INSPECTION NOTE

Name of Work: Setting up of semi-permanent/temporary ICU Hospitals at Shalimar Bagh (G+3) (1430 Beds), Kirari (G+4) (458 Beds) and Sulatanpuri (G+3) (525 Beds) - Package-I.

Agmt. No. : 09/EE/HMD(N)/PWD/2021-22

ICU Hospital, Sultanpuri

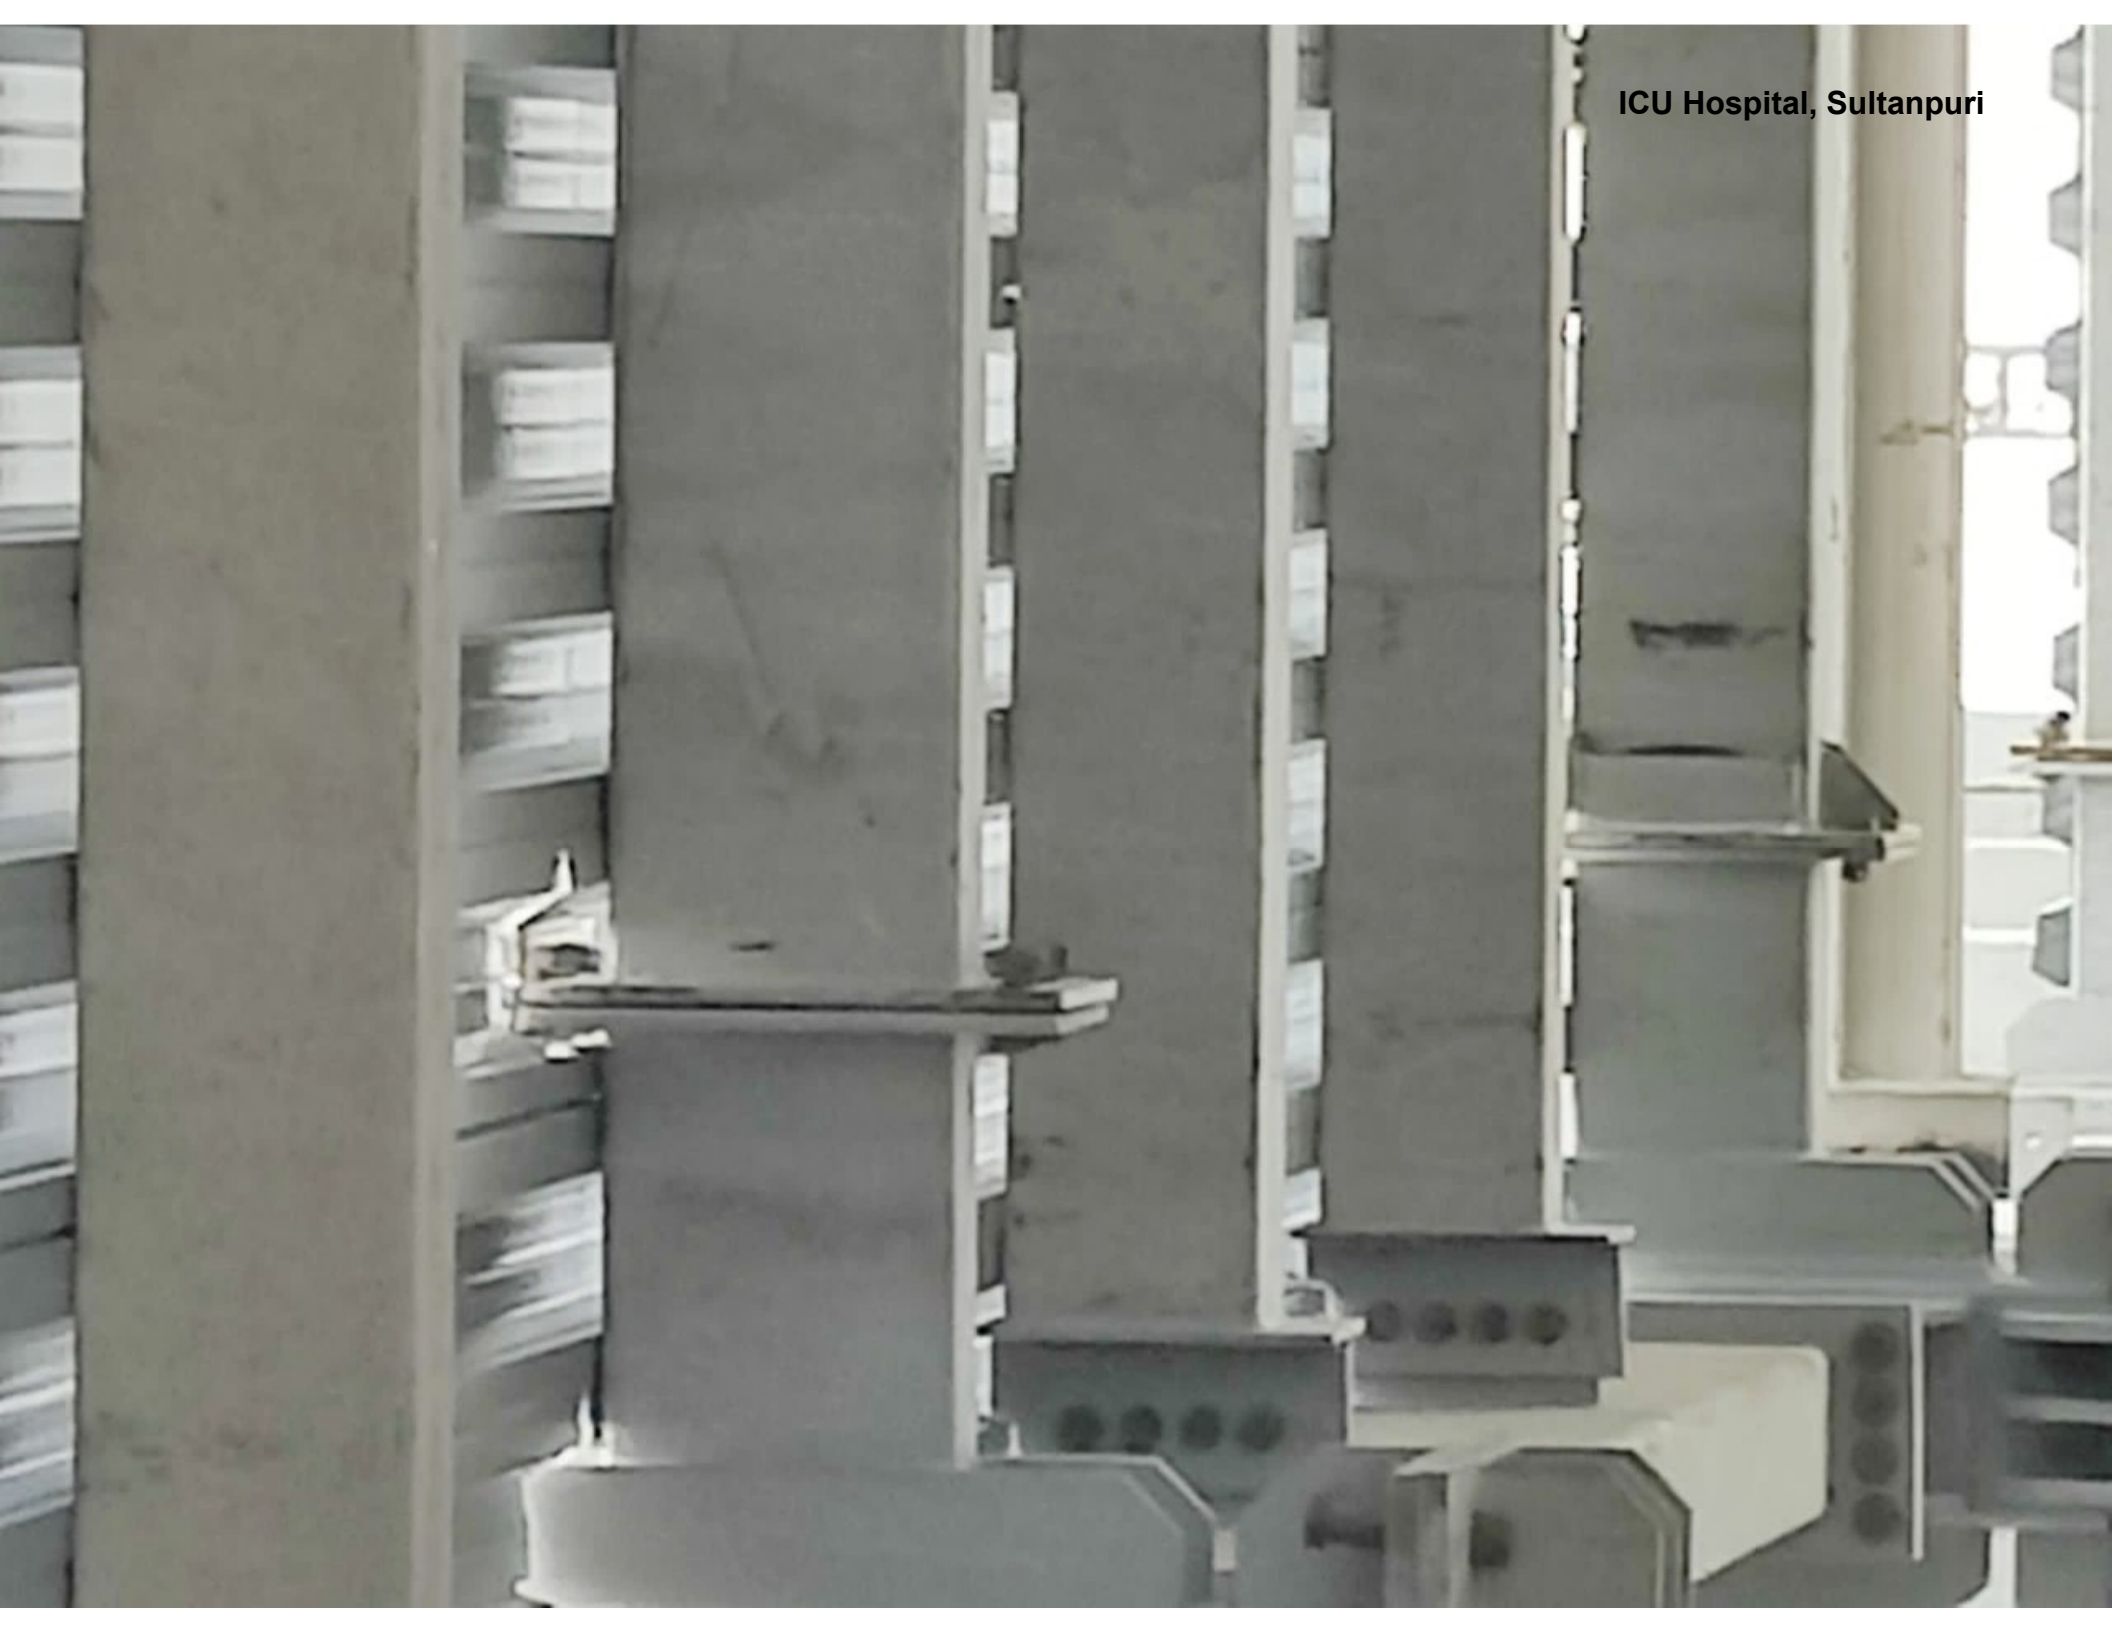
1. At some places, the welding of the structural members was not proper and even arc welded at site, which may lead to structural failure of particular member or members as a group. However, the factory fabricated structural members with MIG welding is taken in the agreement.
2. It was seen that at some places the HSFG bolts in beam to beam and column to column connections were not tightened properly. At many of the places, the bolts installed were under size in length and the nuts are protruding out of threads of the bolts. All this making the structure unstable and unsafe.

The same has been reiterated many times during site inspections as well as by inspection notes but all in vein. Hence, the same to be checked thoroughly and the necessary rectifications to be made at all places. The representative of the contractor, AE, JE of PWD and TPQA should prepare the details of each and every joint and give the certificate that the HSFG bolts installed are of appropriate size as per drawings and tightened as per required torque. No further work to be progressed till the rectifications are made.

3. It was also observed that the beam members between the columns are under size, making a gap between plate to plate. These under sized beams to be replaced with proper size beams as per the drawings to make the structure stable and safe. No further work to be progressed till the rectifications are made.
4. At some places, the deck sheets in the sunken portion was not supported by the cleat angle. It may be ensured that the deck sheet should properly rest on cleat angles in the sunken area.
5. It was seen that in one of the staircase, the waist slab of the staircase was of thickness between 25-50mm, whereas, as per structural drawings it should be 94 mm. The complete staircase to be dismantled and cast as per the approved drawings.
6. The waterproofing treatment of the lift pit to be ensured before concreting of ground floor slab.
